SERVICE BULLETIN

Change of measurement method from cylinder head temperature to coolant temperature for ROTAX® Engine Type 912 and 914 (Series)

ATA System: 75-00-00 Cool system

Change of measurement method from cylinder head temperature to coolant temperature for ROTAX® engine type 912 and 914 (Series).

Fig. 1

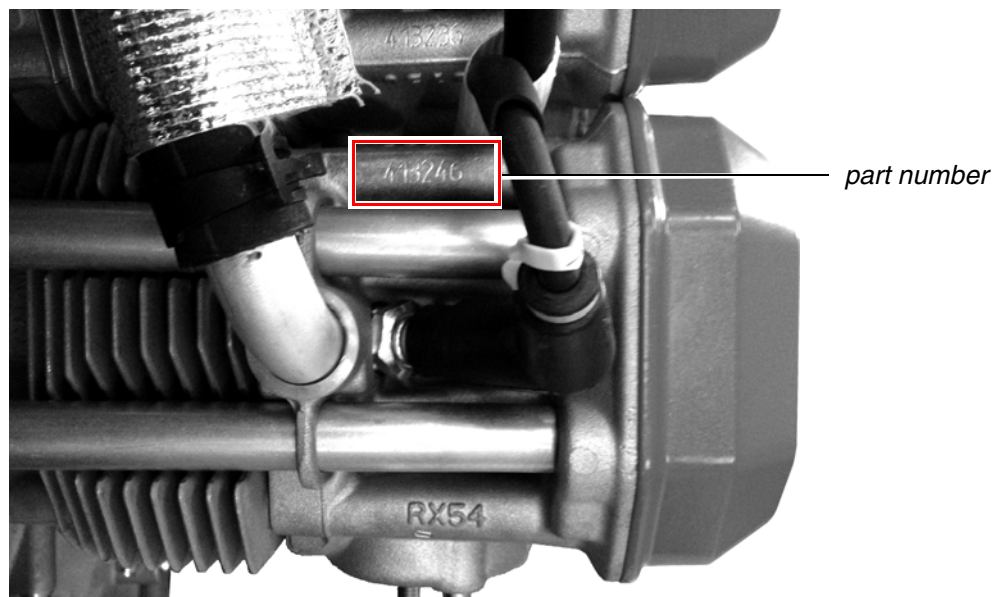
Step	Procedure
1	Check the engine serial number S/N, if the aircraft is affected by this SB.
2	Check of maintenance documentation if a repair or maintenance was performed on one of the cylinder heads.
3	Check the part numbers of the cylinder heads. See Fig. 1.
4	Check of the cockpit (indicating instruments) or the aircraft-specific manuals or consultation with the aircraft manufacturer or its service facilities if the coolant temperature or cylinder head temperature is displayed.
5	The measurement position naming in the indicating instrument or the operating limit must be amended or corrected in consultation with the aircraft manufacturer, if necessary. See section 3.1.1)

Fig. 2

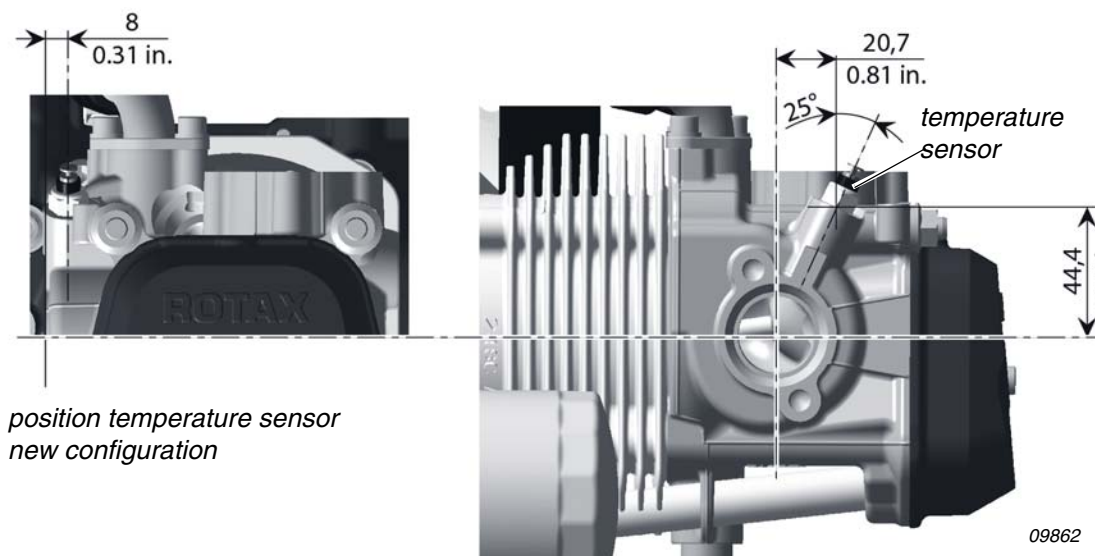
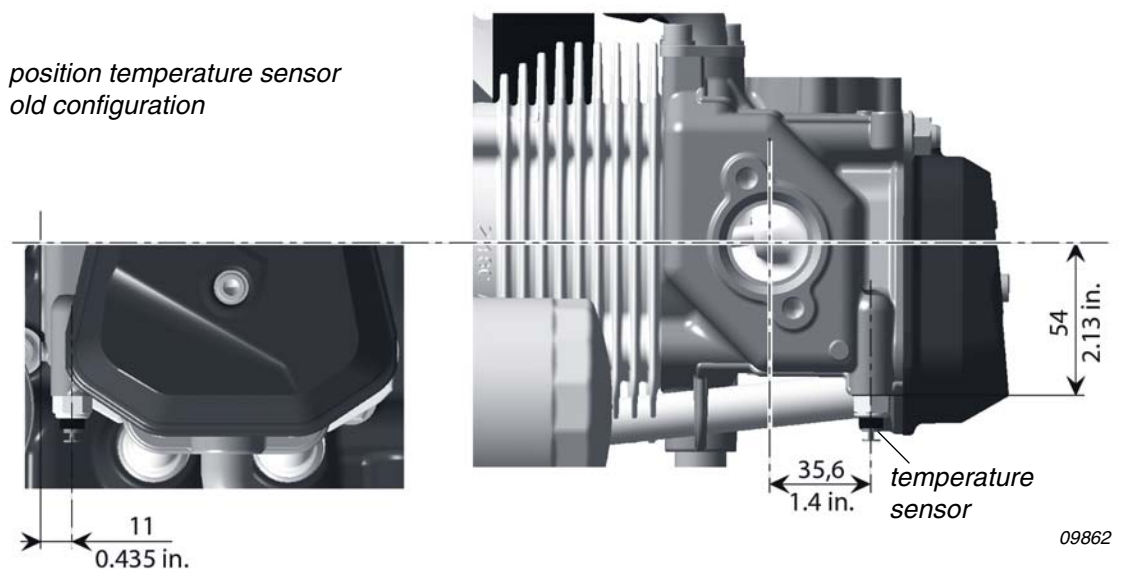
NOTE: Identifying of new cylinder heads: The electrical connection of the temperature sensor is pointing upwards. New configuration see [Fig. 2](#). Old configuration see [Fig. 3](#).

Regarding change of temperature sensor position, see Fig. 2 and Fig. 3.

NOTE: It is NOT mandatory to retrofit engines with the old cylinder heads. The different versions of the cylinder heads can be mixed installed, but make sure, if and at which position the cylinder head temperature and coolant temperature is measured. This also defines the naming of the indicating instrument with the appropriate temperature limit.

Coolant temperature limit for measuring point in the cylinder head (new configuration)	Engine type
maximum 120 °C (248 °F)	912 A/F/S
	914 F
Permanent monitoring of coolant temperature is necessary
